# SERVICE BULLETIN

M-1207

Safety Recall Code 0130

## 2007 SOFTAIL BATTERY CABLE ROUTING RECALL

Figure 1. Battery Cable Orientation

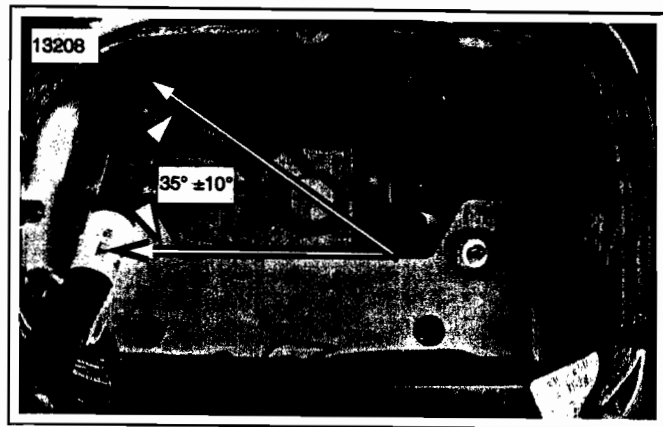
4. See Figure 1. Reposition positive battery cable routing at starter. Cable must face  $35^{\circ}$  forward from left side of vehicle  $\pm 10^{\circ}$ .

5. Loosen starter nut and adjust positive cable to proper orientation. Tighten starter nut to 70-90 In-lbs (7.9-10.2 Nm).
6. See Figure 2. Clip battery caddy to front of battery tray. Be sure tabs (2) of caddy fit over rear of battery tray (3).

Figure 3. Battery Caddy Wiring

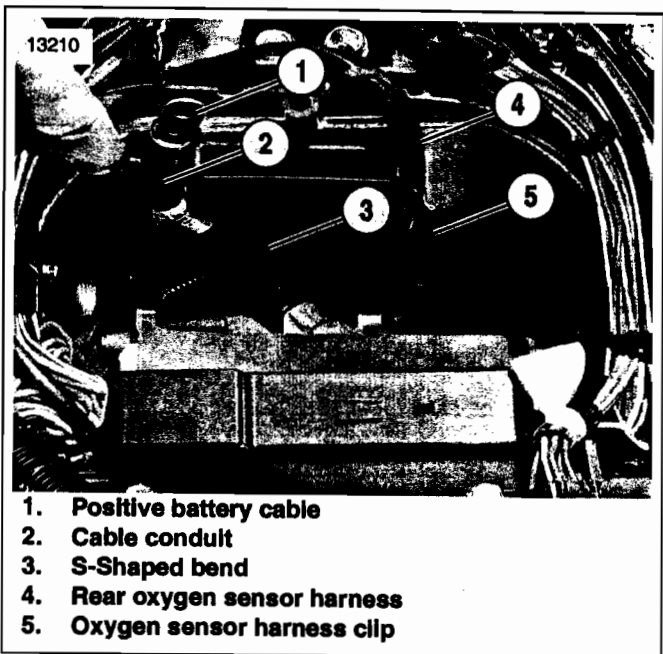
7. See Figure 3. Install positive battery cable (1) into clip in caddy. Be sure S-shaped bend (3) in cable is present and cable conduit (2) is positioned adjacent to terminal as shown.

8. Route rear oxygen sensor harness (4) through clip (5).
